SUBJECT: M20V ALTERNATOR WIRING, MOUNTING AND SECURITY
[Chapter 24 - ELECTRICAL POWER]

MODELS/ SN Mooney M20V - 33-0001 THRU 33-0018
AFFECTED:

SBM20- 340A Page 1 of 5

Figure SB M20-340-1 - EXISTING ALTERNATOR WIRE ROUTING

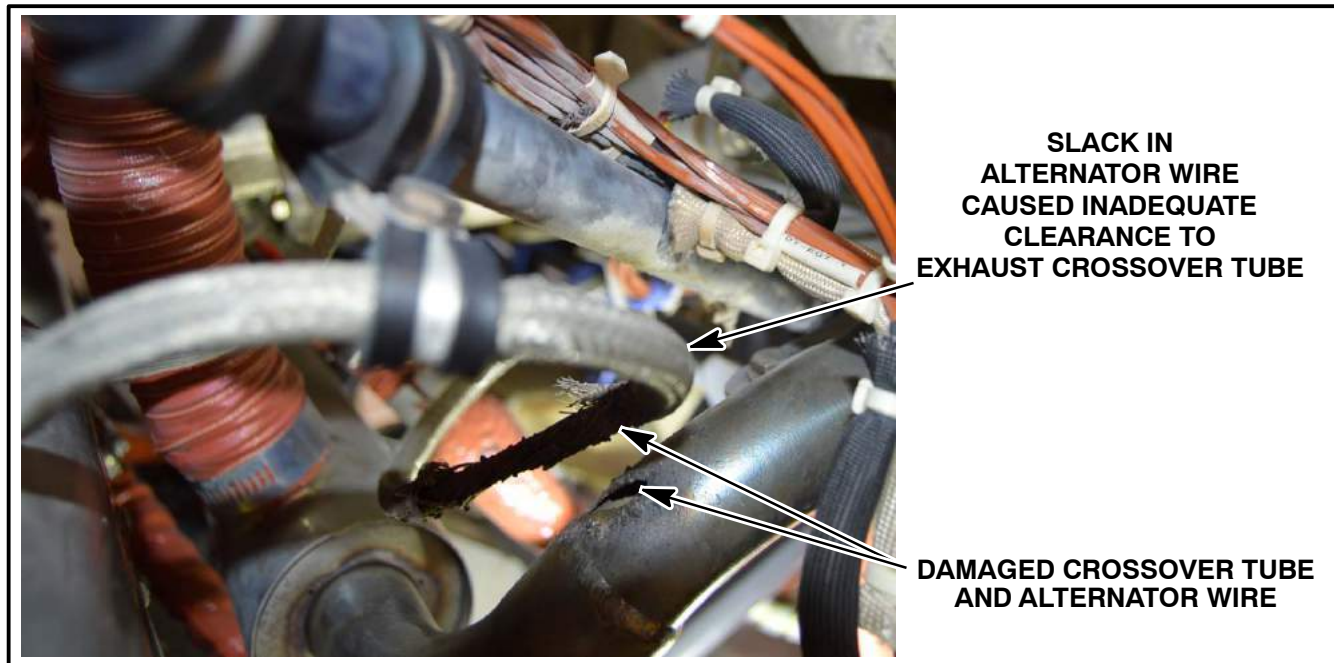
INTRODUCTION: There was a report in the field, of an M20V Acclaim Ultra with an alternator wire damaged on the RH exhaust crossover tube. Mooney Engineering has determined the wire was incorrectly positioned. This allowed the wire to contact the RH exhaust crossover tube causing a short circuit to the alternator. This resulted in damage to the wire and crossover tube. This requires mandatory compliance by owners. **The attached compliance card needs to be filled out and returned to Mooney International Corporation upon completion of this Service Bulletin M20- 340A.**

- 1.1. Turn master switch - OFF.
- 1.2. Remove top and bottom cowling, refer to Mooney Service and Maintenance Manual.
- 1.3. Locate upper alternator wire (refer to Figure SBM20-340-1). Inspect wire for any signs of damage; chafing, cracks in shielding, burnt spots, etc., if wire is damaged, contact MOONEY TECHNICAL SUPPORT support@mooney.com for a replacement wire.

- 1.4. Locate RH exhaust crossover tube. Inspect for damage; holes, cracks, etc., if damaged contact MOONEY TECHNICAL SUPPORT support@mooney.com for a replacement crossover tube, refer to Figure SBM20-340-1.
